CITY PLAN COMMISSION**THURSDAY, OCTOBER 24, 2024****FILE NUMBER:** S234-207**SENIOR PLANNER:** Hema Sharma**LOCATION:** High Mesa Drive, north of High Bluff Drive**DATE FILED:** September 25, 2024**ZONING:** R-7.5(A)**CITY COUNCIL DISTRICT:** 13**SIZE OF REQUEST:** 0.414-acres**APPLICANT/OWNER:** Rizos Land Group NW HWY LLC

REQUEST: An application to replat a 0.414-acre (18,020 square feet) tract of land containing all of Lot 33 in City Block 12/6616 to create one 8,232 square foot lot and one 9,788 square foot lot on property located on High Mesa Drive, north of High Bluff Drive.

PRELIMINARY PLAT
RZOS HIGH MESA
 GEN. PLAN OF LOT 33, BLOCK 129816,
 HIGHLAND RECREATION ADDITION,
 CITY OF DALLAS, DALLAS COUNTY, TEXAS
 CITY PLAN FILE NO. 5234-207
 DATE: 08/20/2024, LARS & KATHRYN | SCALE: 1" = 30' (ADMS)

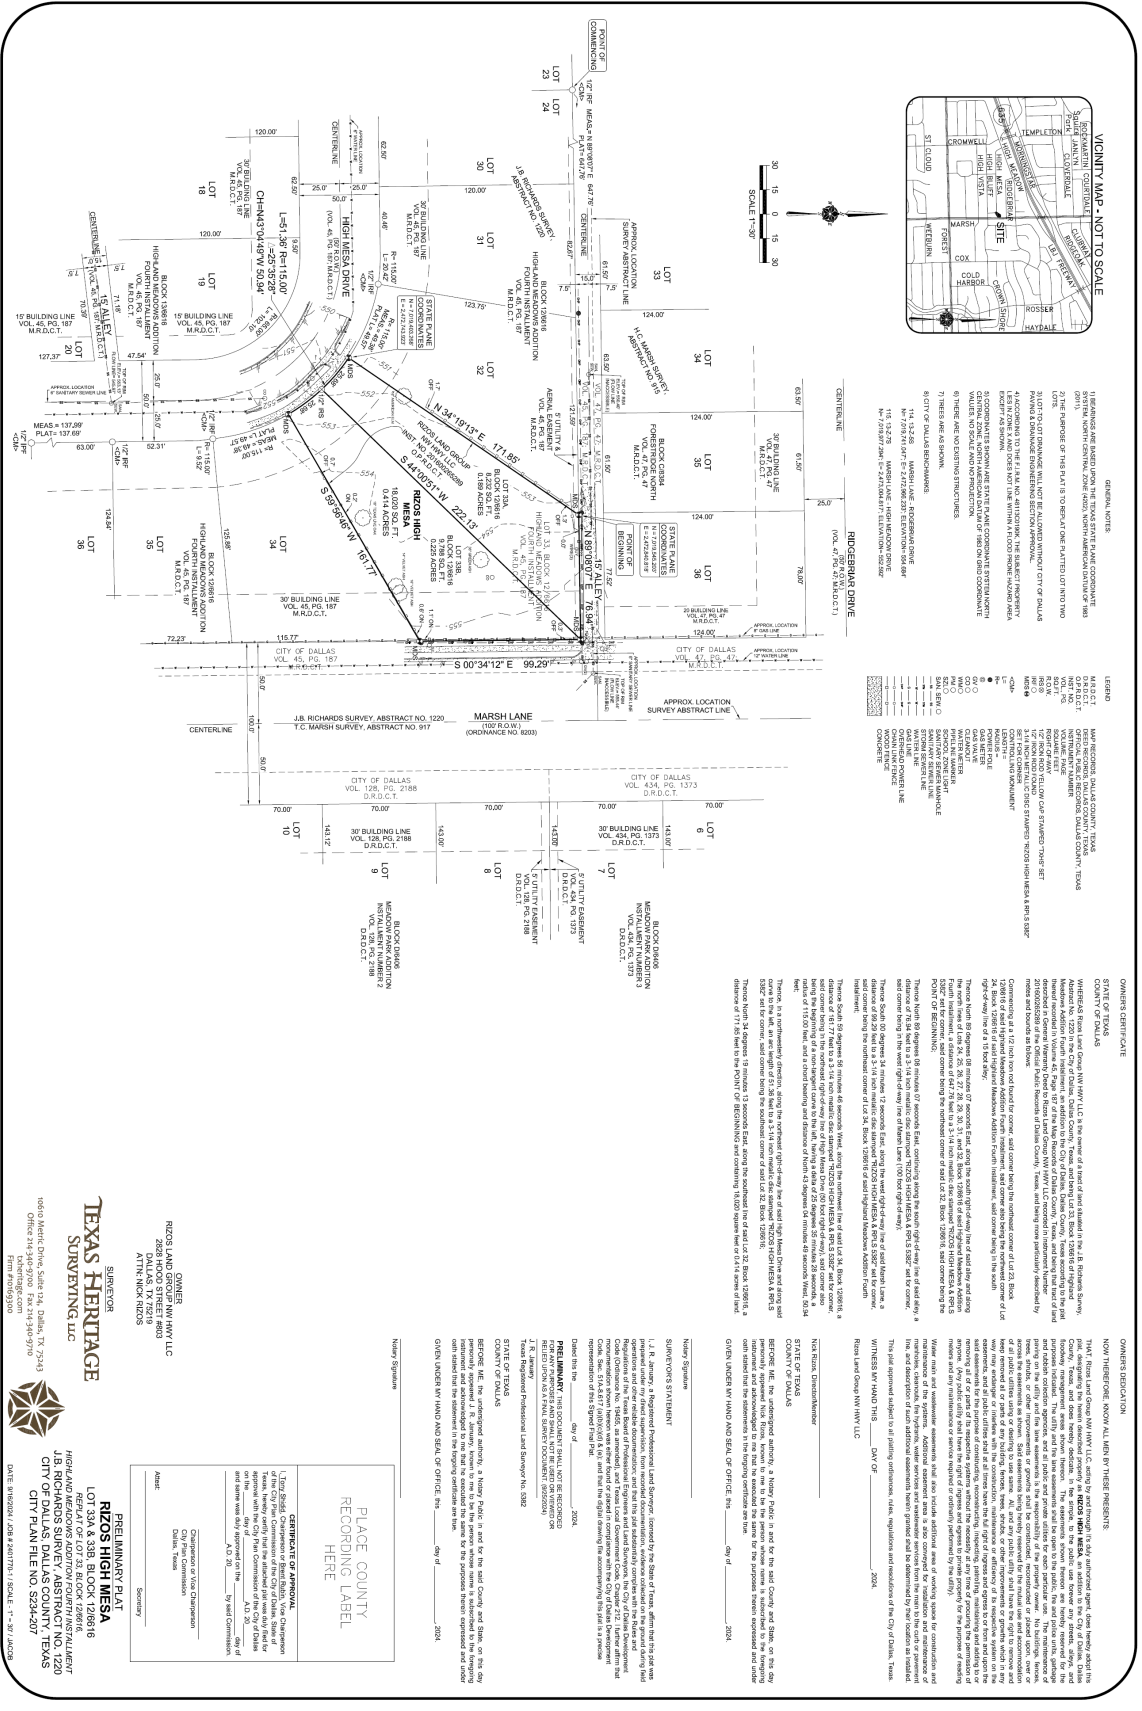
STAFF RECOMMENDATION: Section 51A-8.503 states that “lots must conform in width, depth and area to the pattern already established in the adjacent areas, having due regard to the character of the area, its particular suitability for development, and taking into consideration the natural topography of the ground, drainage, wastewater facilities, and the proposed layout of the streets.”

- The properties to the north, south and west have lot areas ranging in size from 7,435 square feet to 11,950 square feet and lot widths are ranging from 49.57 feet to 77.50 feet are zoned R-7.5(A) Single Family District. (*Refer to the existing area analysis map*)

The request lies in R-7.5(A) Single Family District which has a minimum lot area requirement of 7,500 square feet. The request is to create one 8,232 square foot lot and one 9,788 square foot lot. The proposed lot widths are 25.68 feet each.

The majority of lots within the immediate vicinity of the request are with similar lot pattern. The proposed widths are half the size than most of the lots in the immediate vicinity. (*Refer to the existing area analysis map*). Staff finds that there is a lot pattern and the request complies with the requirements of R-7.5(A) Single Family District, however does not comply with the requirement of Section 51A-8.503; therefore, staff recommends denial of the request. However, should the commission approve the request, staff recommend that the approval be subject to compliance with the following conditions:

5. Any new or existing structure may not extend across new property lines. *Section 51A-8.503(e)*
6. On the final plat, all easement abandonments, and ROW abandonments must be by separate instrument with the recording information shown on the face of the plat. A release from the Real Estate Division is required prior to the plat being submitted to the Chairman for signature.

7. On the final plat, include two boundary corners tagged with these coordinates: "Texas State Plane Coordinate System, North Central Zone, North American Datum of 1983 on Grid Coordinate values, No Scale and no Projection."

8. On the final plat, monument all set corners per the Monumentation Ordinance. Prior to submittal of the final plat for the Chairman's signature. The monuments must be verified by the Chief City Surveyors Office in the Public Works Department. *Section 51A-8.617*

11. The number of lots permitted by this plat is 2.

12. Place a note on the final plat stating "Lot-to-Lot drainage will not be allowed without proper City of Dallas Engineering Division approval" 51A 8.611(e)
13. Submit drainage, paving, etc. plans prepared by a licensed (TX) Professional Engineer to Permit Center, Oak Cliff Municipal Center (i.e. non-311T/DP). *Section 51A- 8.102 (c); 8.601(b)(4),(5),(6),(7),(8),(9)*

14. On the final plat, dedicate a 15-foot by 15-foot Alley Sight Easement at the intersection of Marsh Lane & the alley. *Section 51A-8.602(e)*

16. Engineer must furnish plans for water and sanitary sewer. Developer must furnish a contract for water and sanitary sewer. Sections 49-60(g)(1) and (2) and 49-62(b), (c), and (f).
17. Additional design information is required for assessment. Site plan must be submitted showing proposed development, building finished floor elevation, development, existing mains – including downstream manhole, and proposed water and wastewater service locations. Submit water/wastewater engineering plans to 320 E. Jefferson Blvd., Room 200, Attention: Water and Wastewater Engineering.
18. Wastewater main improvements is required by Private Development Contract. Submit water/wastewater engineering plans to 320 E. Jefferson Blvd., Room 200, Attention: Water and Wastewater Engineering.

19. On the final plat, identify the property as Lots 33A & 33B in City Block 12/6616.
